Delegated Report

Planning Application No: 20220424

Location: 4 High Street Northfleet Gravesend Kent

Description: EDC Consultation EDC/21/0209 - Erection of a three storey building providing 7no. residential units and associated car parking, amenity space and landscaping.

The current application has been revised altering from 6no. units comprising four 2-bedroom flats and two one-bedroom flats to 7no. comprising of five 2-bedroom flats and two one-bedroom flats. In respect of the ground floor the revised layout is shown below alongside the original submitted layout:

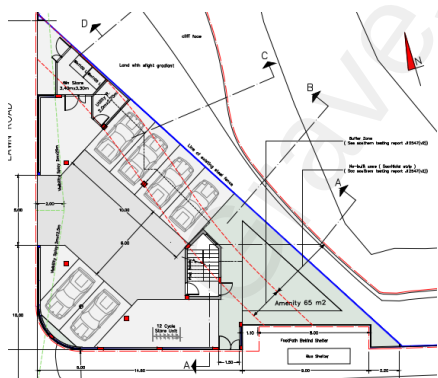
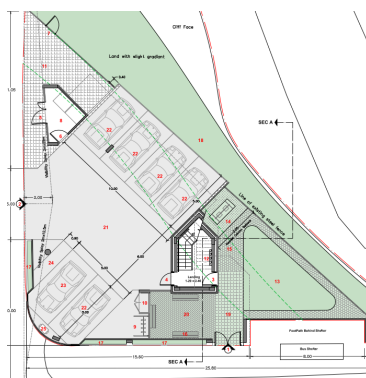
This is an intensification of a proposal that has already been exhaustively analysed.

The swept path for the additional parking space demonstrates that whilst the vehicle may be able to access the parking space in forward gear the reverse out manoeuvre will have significant reduced visibility as the visibility splay is based on driving forward onto the highway.

Rule 201 of the Highway Code states. When, using a driveway, reverse in and drive out if you can. I see no reason why that cannot occur here, but in driving out in forward gear vehicles would have to travel on the wrong side of the road in close proximity to a junction where visibility would be restricted for on coming vehicles due to the adjacent junction. I therefore consider the use of the parking space to be hazardous, even if vehicle speeds may be low it will be an unexpected situation and would recommend refusal on highway safety grounds. It should be also noted that visibility splays are always measured to the nearside edge of the carriageway and not the centre line of the main carriageway except in very special circumstances which do not apply here.

On highway safety grounds I therefore recommend refusal.
